Groundwater Transfer Review Summary Form

Transfer/PA # I- <u>14564</u>
GW Reviewer Phillip I. Marcy Date Review Completed: 01/10/2024
Summary of Same Source Review:
☐ The proposed change in point of appropriation is not within the same aquifer as per OAR 690-380-2110(2).
Summary of Water Level Decline Condition Review:
☐ Water levels at the original point(s) of appropriation have exceeded the allowed decline threshold defined by conditions in the originating water right.
Summary of Injury Review:
☐ The proposed transfer will result in another, existing water right not receiving previously available water to which it is legally entitled or result in significant interference with a surface water source as pe 690-380-0100(3).
Summary of GW-SW Transfer Similarity Review:
☐ The proposed SW-GW transfer doesn't meet the definition of "similarly" as per OAR 690-380-2130.
This is only a summary. Documentation is attached and should be read thoroughly to understand the basis for determinations.

OREGON WATER RESOURCES DEPARTMENT	Oregon Water Resor 725 Summer Street N Salem, Oregon 97301 (503) 986-0900 www.wrd.state.or.us	E, Suite A	Ground Water	endment	
Application: T-14564			Applicant Name

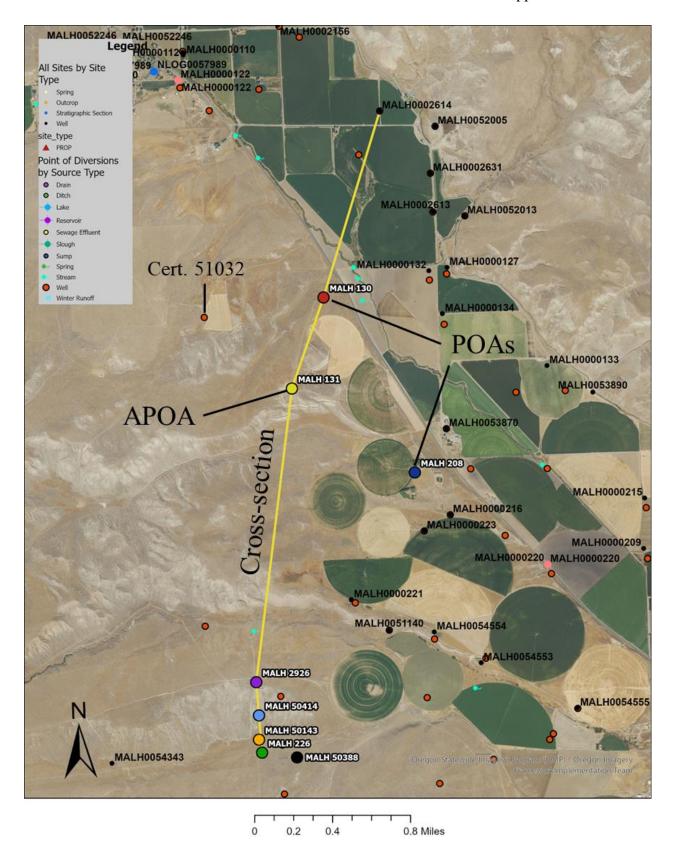
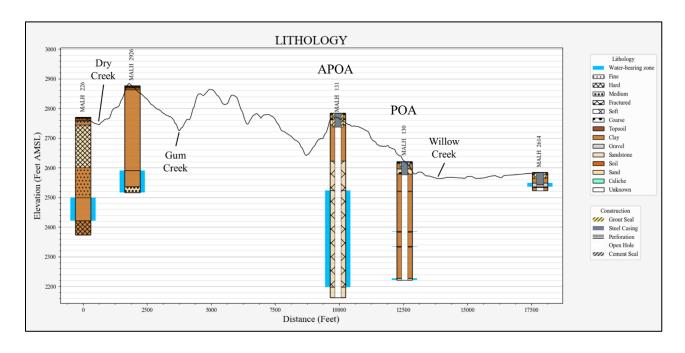
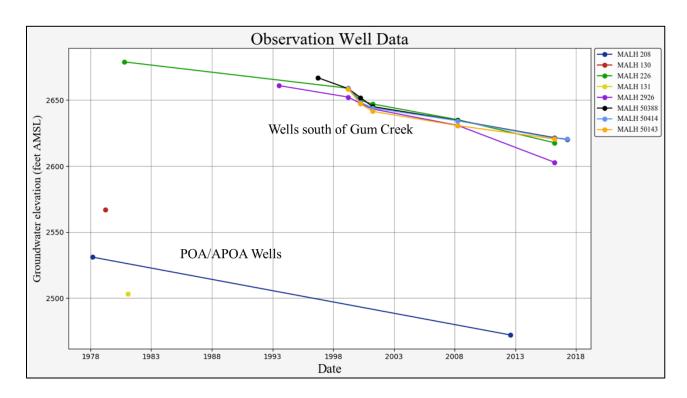
Any additional comments: Ongoing declines in the sedimentary aquifer have been noted in
this area, though data are limited to a period between 1999-2017 and sporadically reported. The attached hydrograph illustrates the difference in head elevation between the POA and APOA wells on this application and those south of Gum Creek, however the trend of MALH 208 suggests that despite the lower elevation of these well sites and closer proximity to the valley-fill sequence, the same declines may be in effect. Note that there are only two water level measurements on MALH 208, one of which was the driller's reported measurement, thus there exists some level of uncertainty about this trend.

b) If yes, at its maximum allowed rate of use, what is the expected change in degree of interference with any surface water sources resulting from the proposed change? Stream: NA
Stream:
Provide context for minimal/significant impact: NA
For SW-GW transfers, will the proposed change in point of diversion affect the surface water source similarly (as per OAR 690-380-2130) to the authorized point of diversion specified in the water use subject to transfer? Yes No Comments: NA
What conditions or other changes in the application are necessary to address any potential issues identified above: <u>Due to concern that additional pumping</u> , and therefore enlargement, may occur by addition of the APOA to this established right, if this transfer is approved the following condition is recommended: <u>Before use begins on the APOA well</u> , a totalizing flowmeter shall be installed and maintained on the APOA well MALH 131 and access to the flowmeter shall be granted to OWRD staff upon reasonable notice.
